Old Stoneybrook Community Association: Helping Grow Forest City

307 Fanshawe Application Z-9006

Multiple Bylaw Infractions

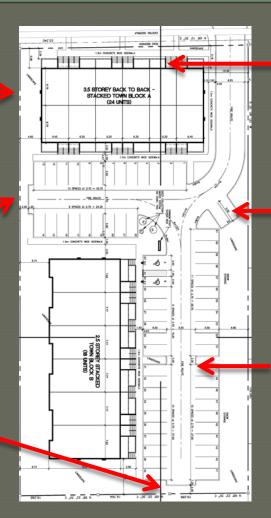
Set back 4.9m

Should be 6.0mbecausewindows

Set back 2. m

- Should be 3.0m

Set back 2.0m

- Should be 3.0m

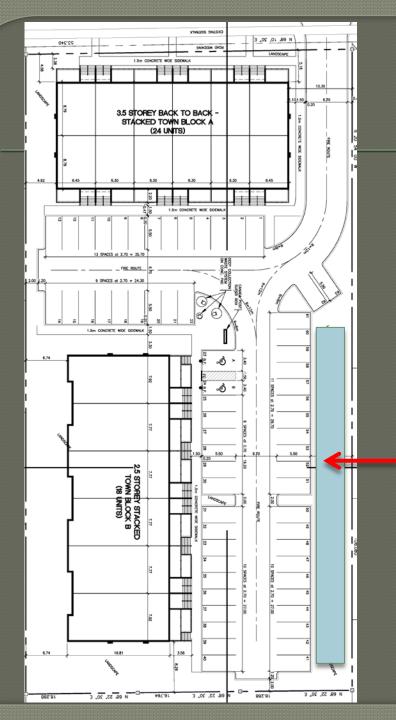
City Planning
Accepts

Reduced

Setback

Set back is

under 3. m

Parking oriented to shine onto neighbors

Contravenes Parking Lot Bylaws
